STRUCTURAL

REVIEWED
FOR
CODE
COMPLIANCE
09/28/2022

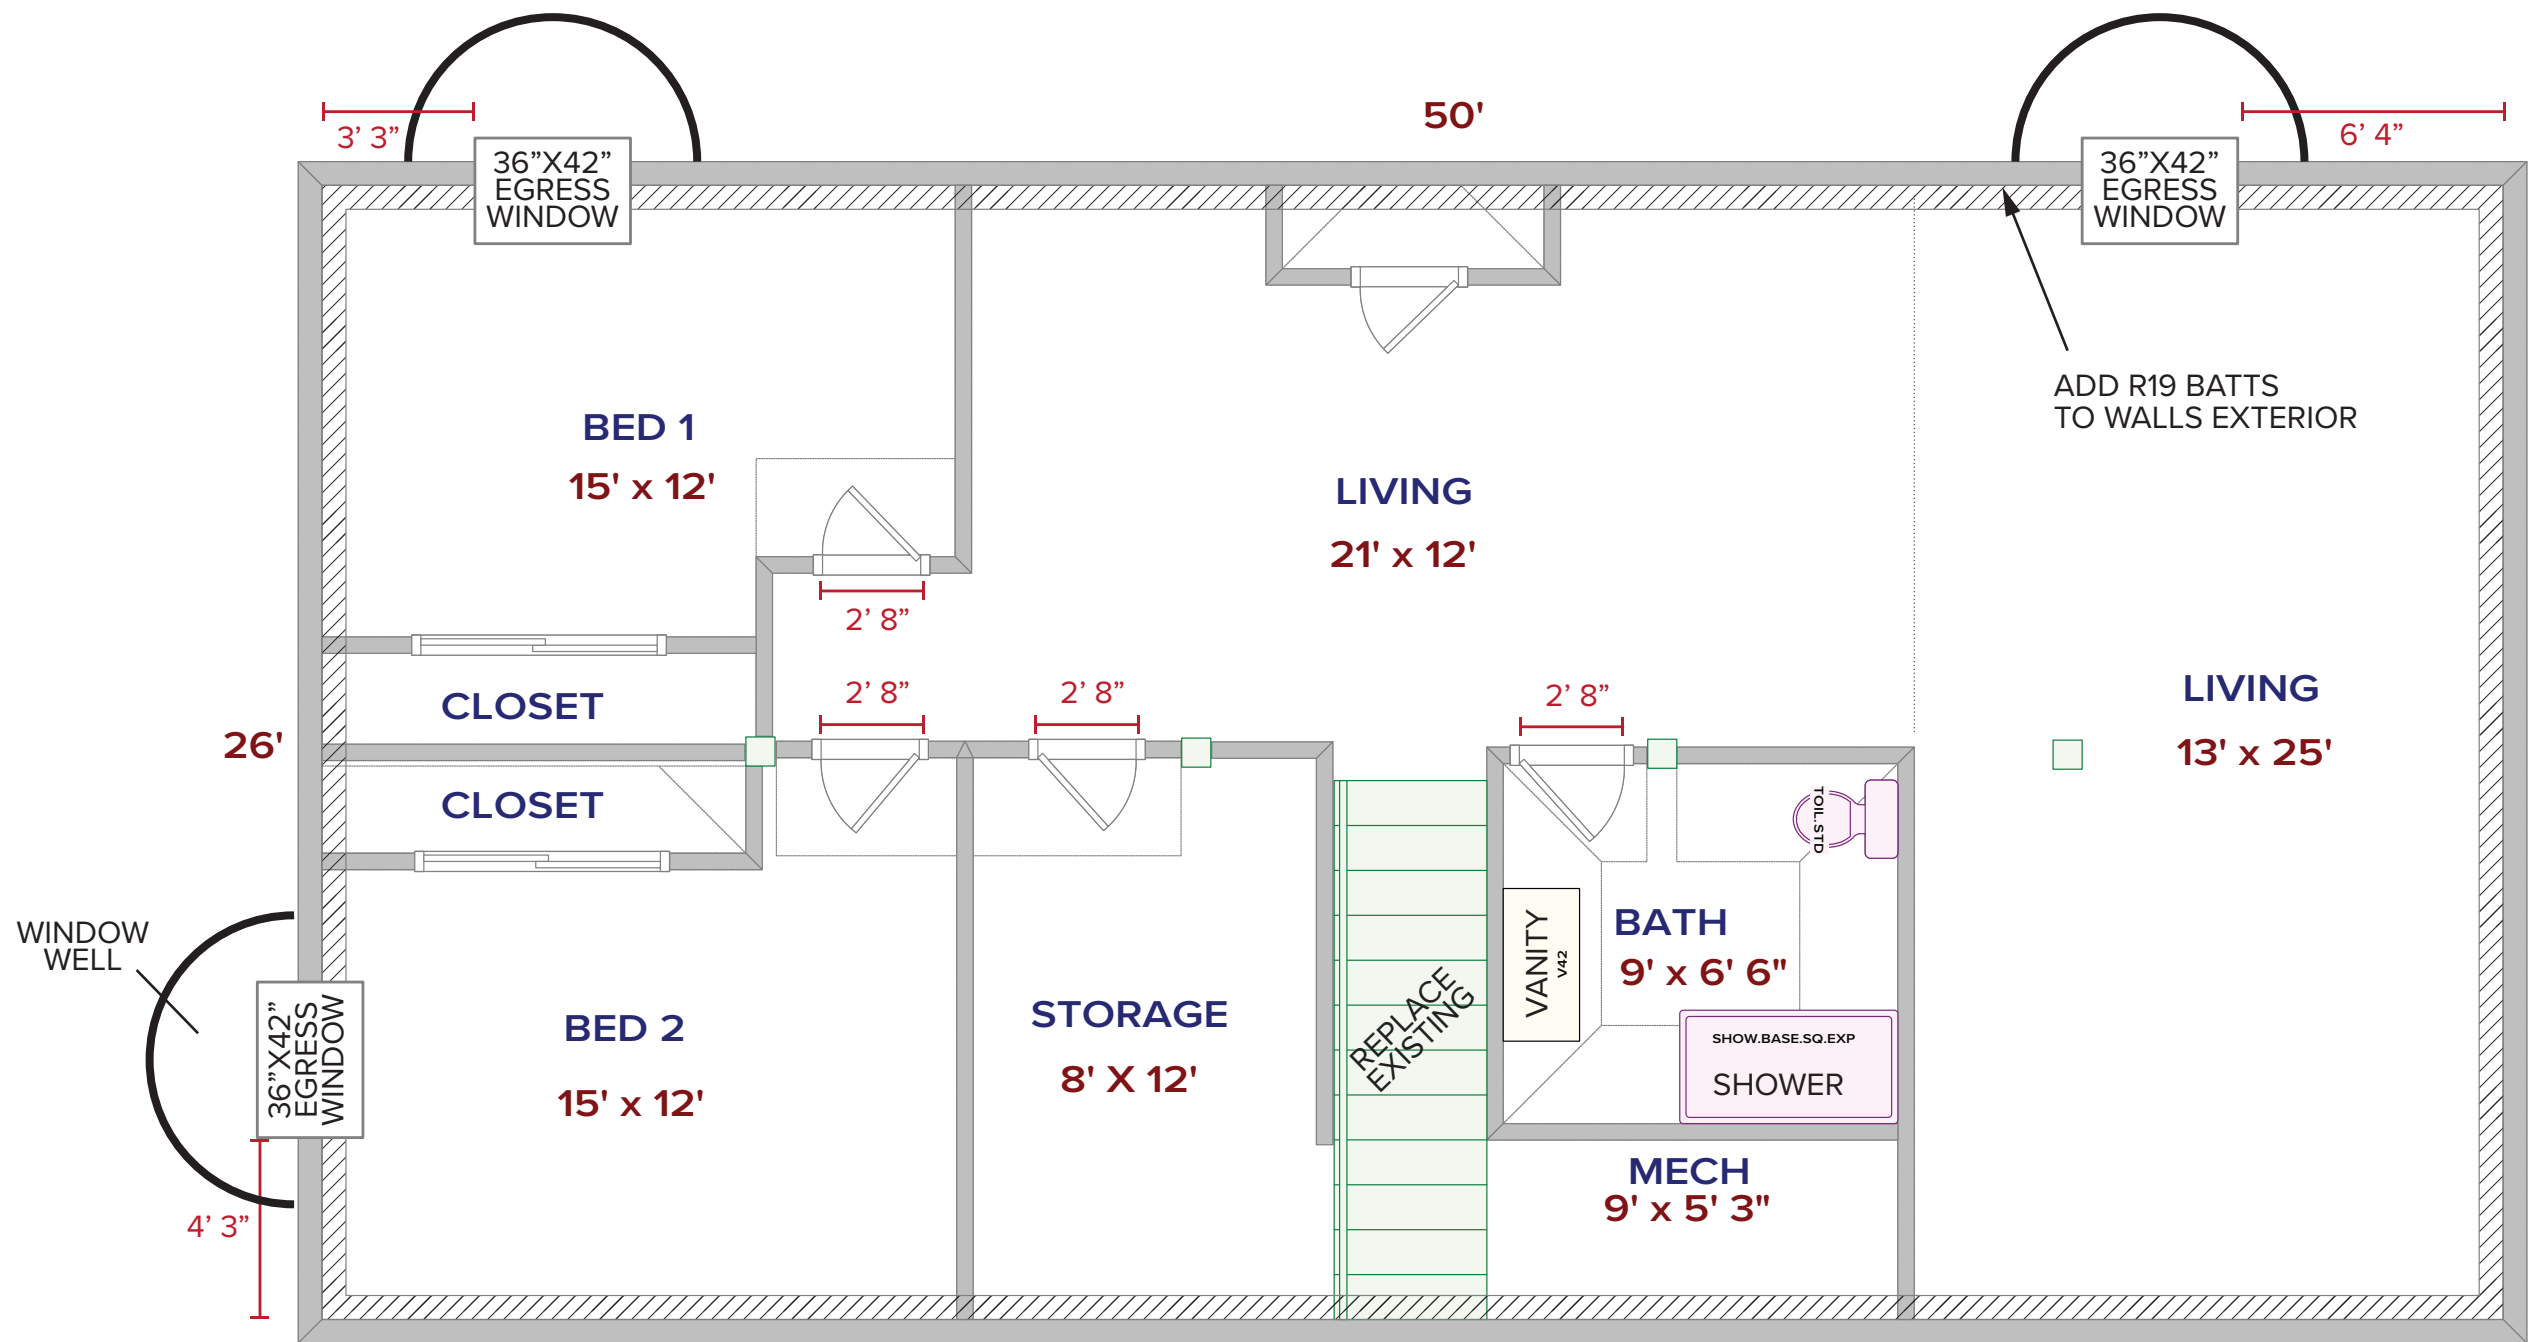
- NOTES:
- Provide and install windows to meet glazing requirements less than or equal to 0.3 U factor.
 - Provide new Stairs and handrails constructed to code per IRC R311.7
